## ANO-1 STEAM GENERATOR TUBE INSPECTION DISCUSSION POINTS

May 10, 2013

The following discussion points have been prepared to facilitate the conference call arranged with the licensee to discuss the results of the steam generator tube inspections conducted during the upcoming spring 2013, Unit 1 refueling outage (1R24). This conference call is scheduled to occur towards the end of the planned SG tube inspections, but before the unit completes the inspections and repairs.

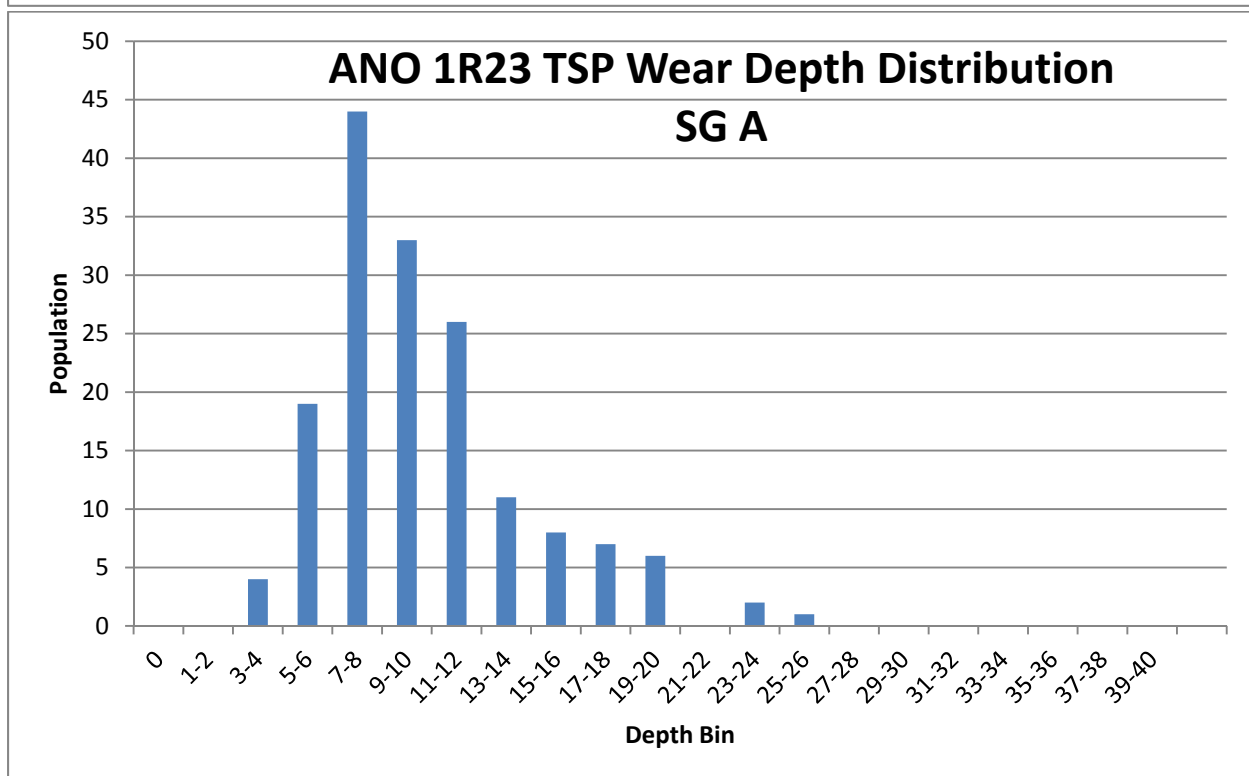
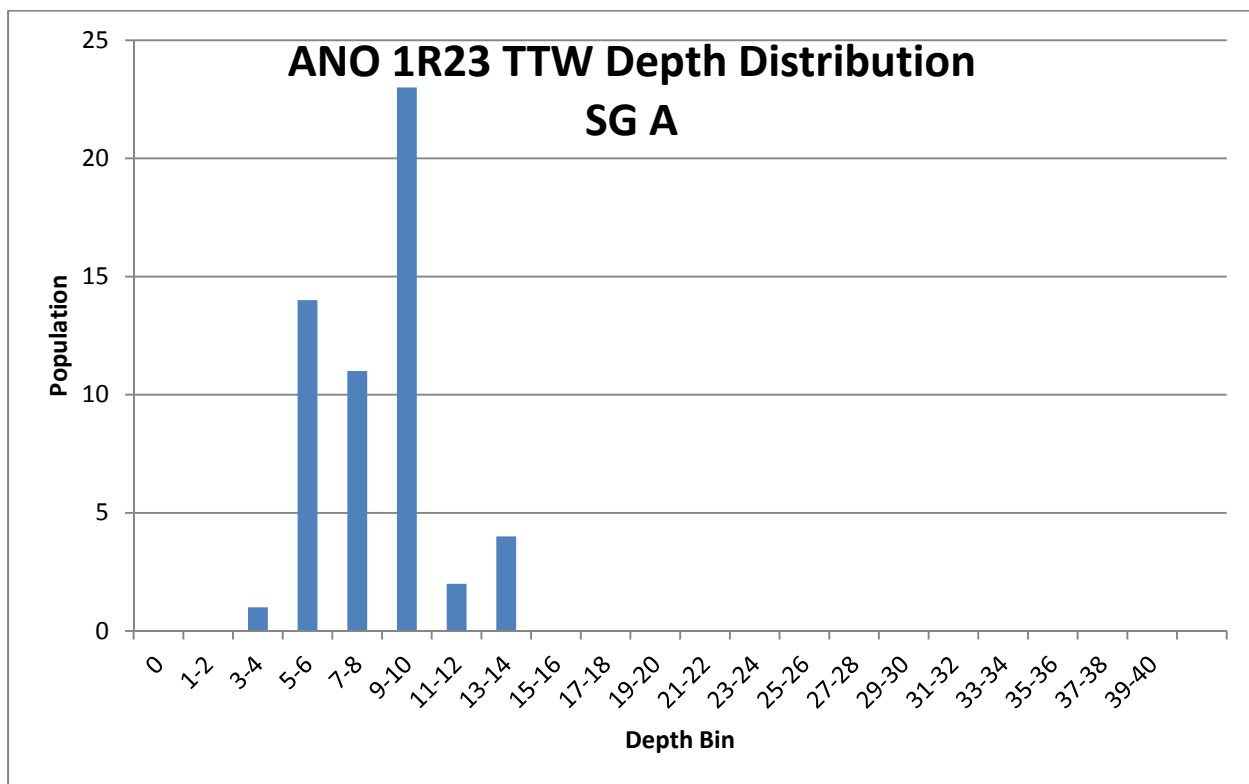
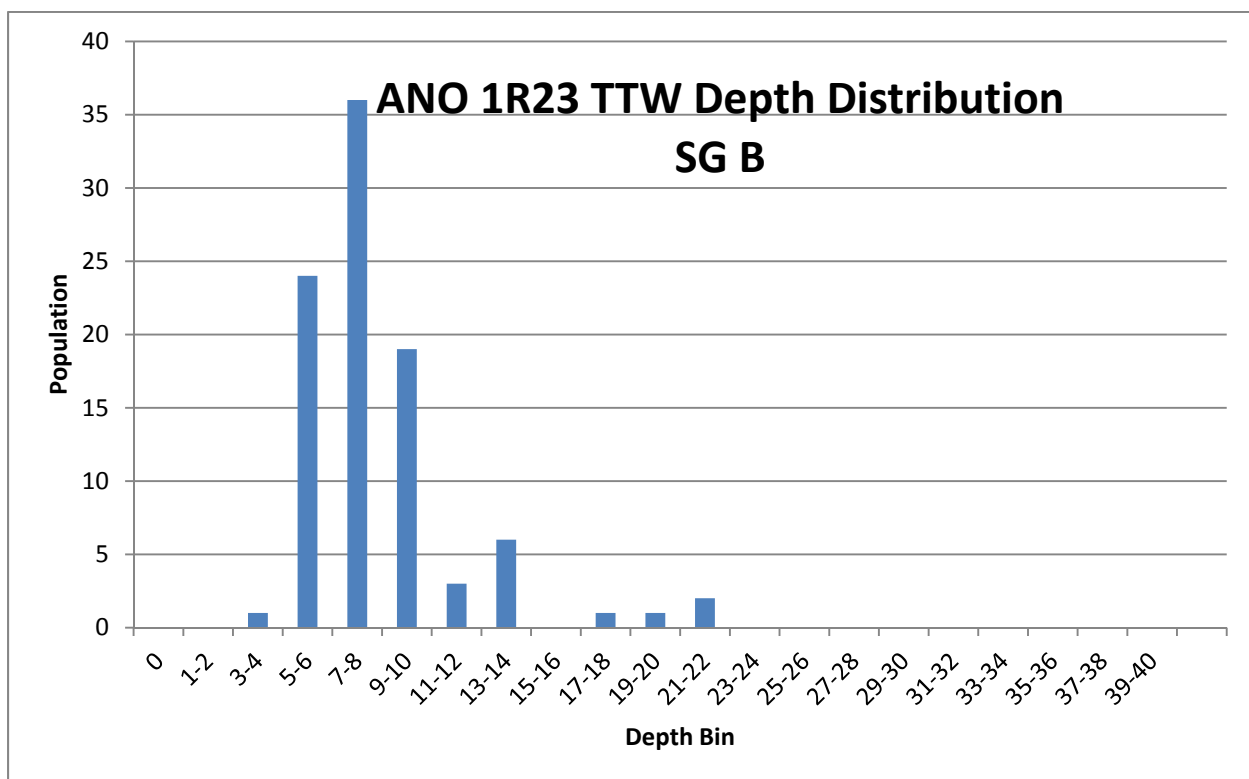
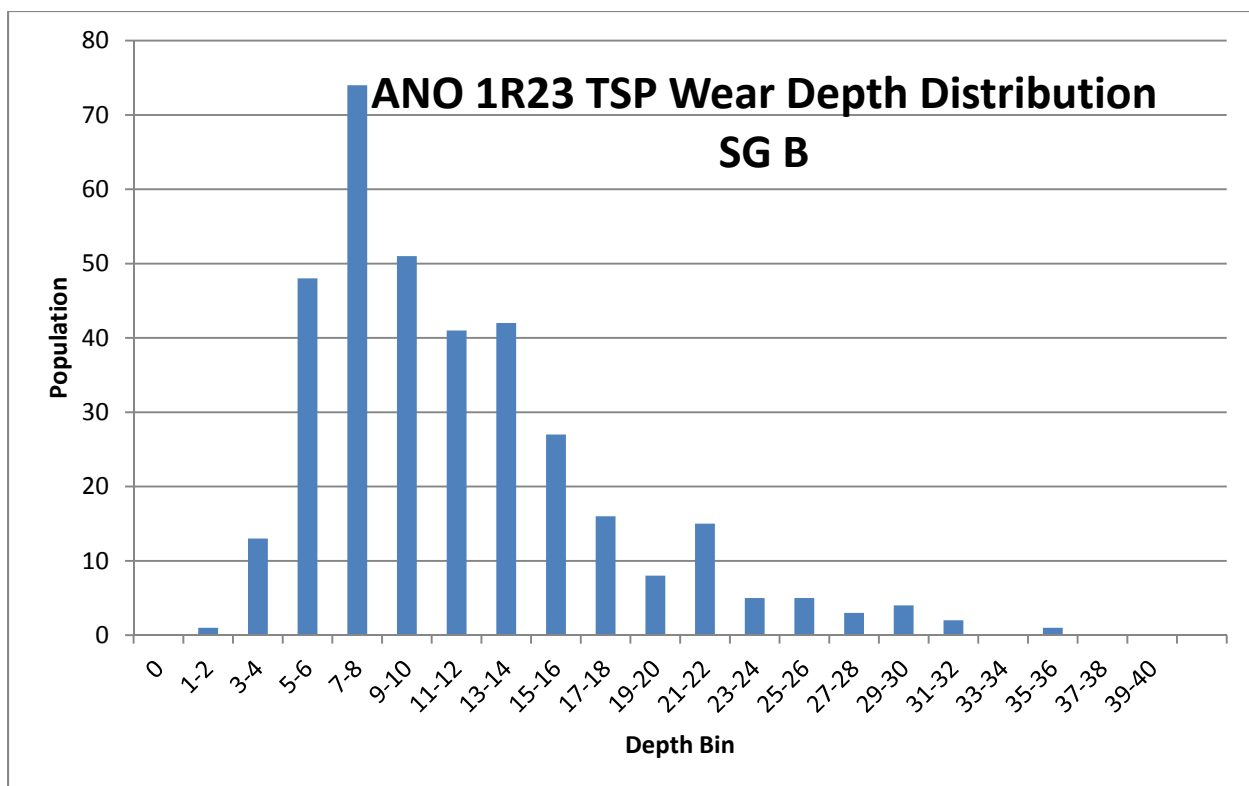
Although not defined as a degradation mode. This inspection was targeted at Tie Rod bowing. The following indication counts were identified in each SG

SG A	SG B
PTB (prox. to tube and tie rod)	11	5
PTU (prox. to tube)	30	9
PTR (prox. to tie rod)	35	17

See Attachments for Tie Rod Extents and Tubesheet Maps
